DEVIATION REVIEW AND DECISION FORM

Subdivision or Project Name: Waterview East Preliminary Plan

Section of ECM from Which Deviation is Sought: Appendix I Section I.7.1.B
Specific Criteria from Which a Deviation is Sought: 1st Bullet; Providing Water Quality for Entire Development

Figure No.
 1.0

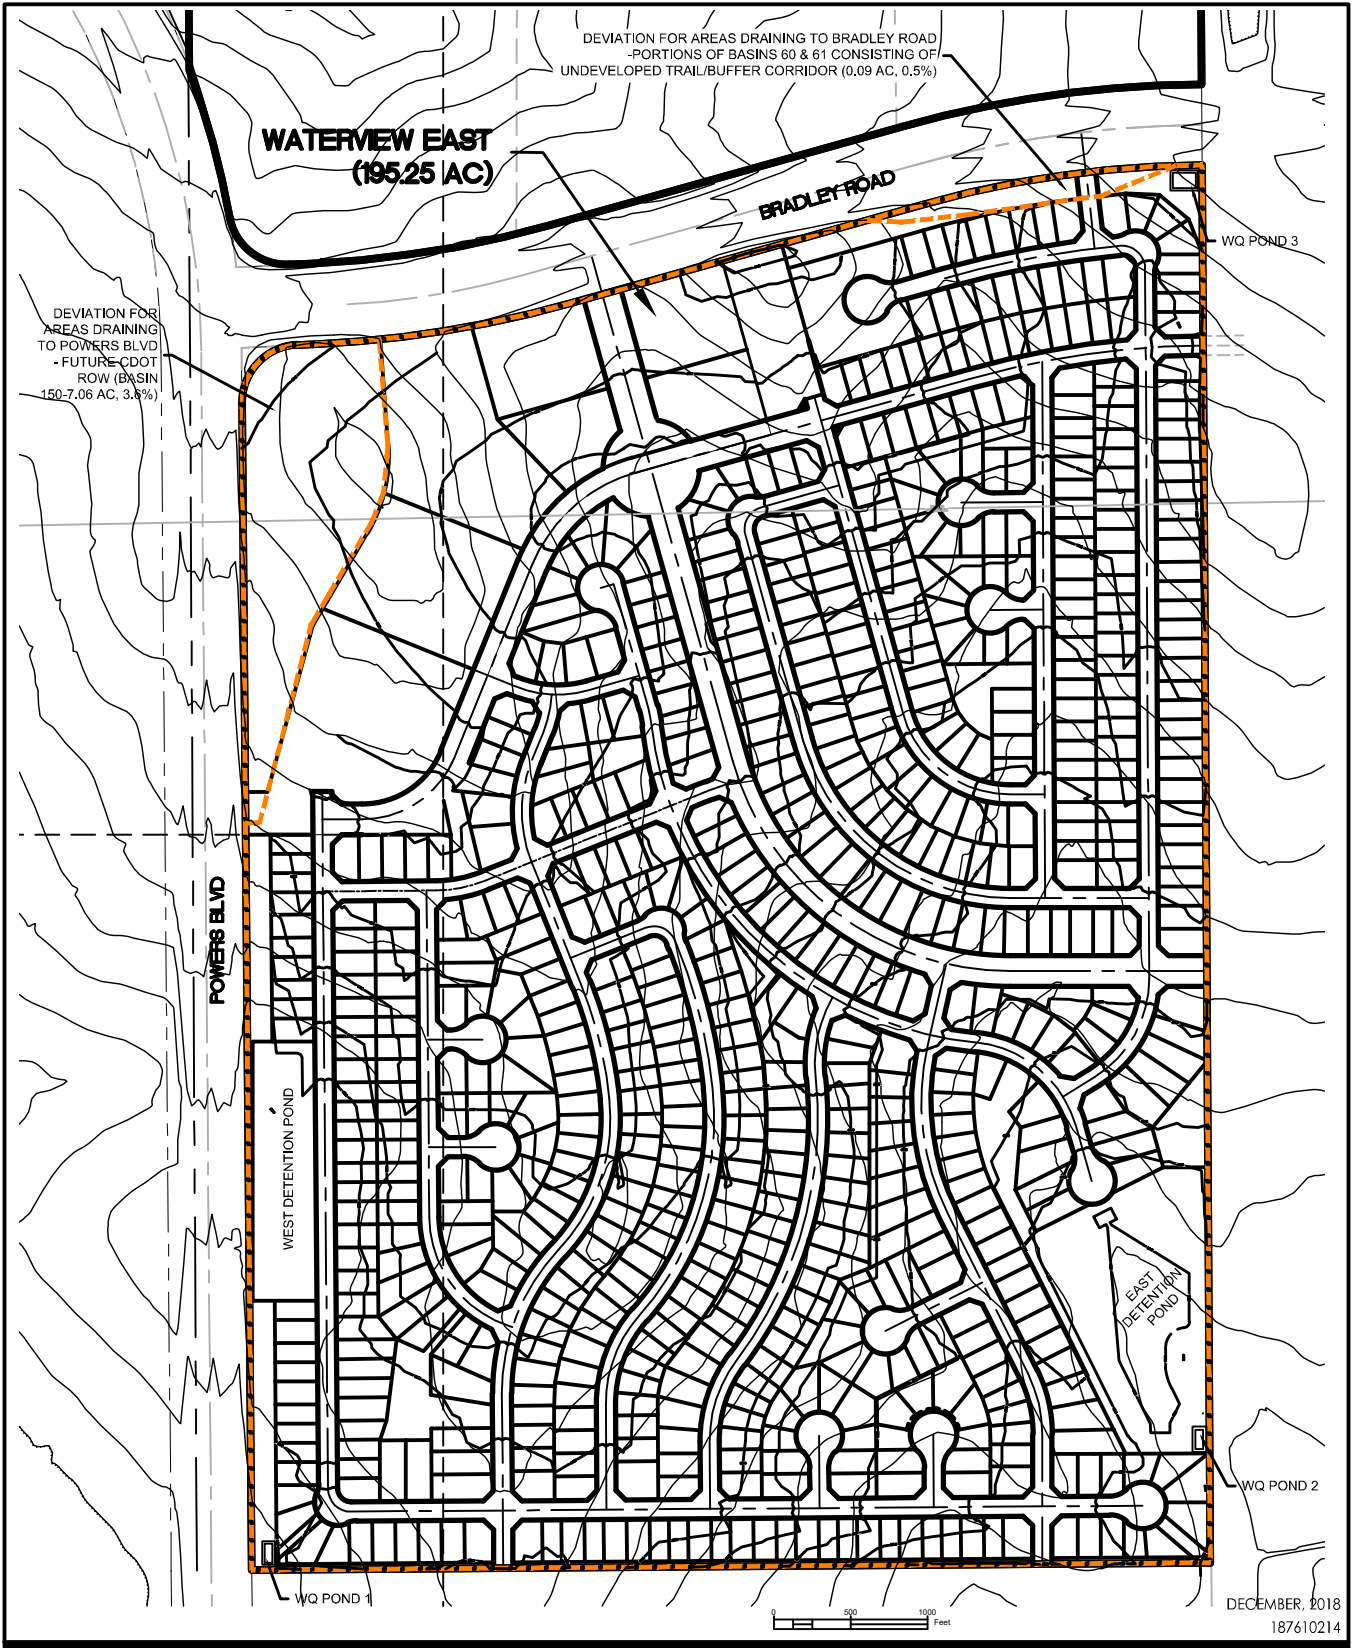
Proposed Nature and Extent of Deviation: Approximately 4.1% (7.96 acres of 195.25) of the area inside the development boundary will not reach a proposed detention pond and/or proposed water quality facility. Of the area inside the development boundary that will not reach a facility only 0.5% (0.9 acres of 195.25) will be undeveloped property consisting only of exterior boundary open space trail corridor/buffer tracts (portions of basins 60 and 61); the remaining 7.06 acres is anticipated future CDOT r.o.w. for the Bradley Road Powers Boulevard interchange (basin 150). The anticipated CDOT area will remain undeveloped until, as anticipated, CDOT will improve the intersection and address water quality at that time.

Reason for the Requested Deviation: The topography of the site will not allow all dedicated trail corridors to drain to proposed detention ponds. These open space/buffer areas consist of only 0.5% (0.9 acres; portions of basin 60 and 61) of the total 195.25 acres of the subject property. The remaining area not proposed for water quality consist of a future CDOT tract for the interchange at Bradley Road and Powers Boulevard (Basin 150). The large trail/buffer tracts do not require detention or water quality because of the nature of the use and the fact that the open space will provide good areas for infiltration of rain water into the ground. The future CDOT area will be the responsibility of that entity for addressing water quality for the entire future interchange at the time of design and construction. In the meantime, the future CDOT area will remain open with only natural grasses in place.
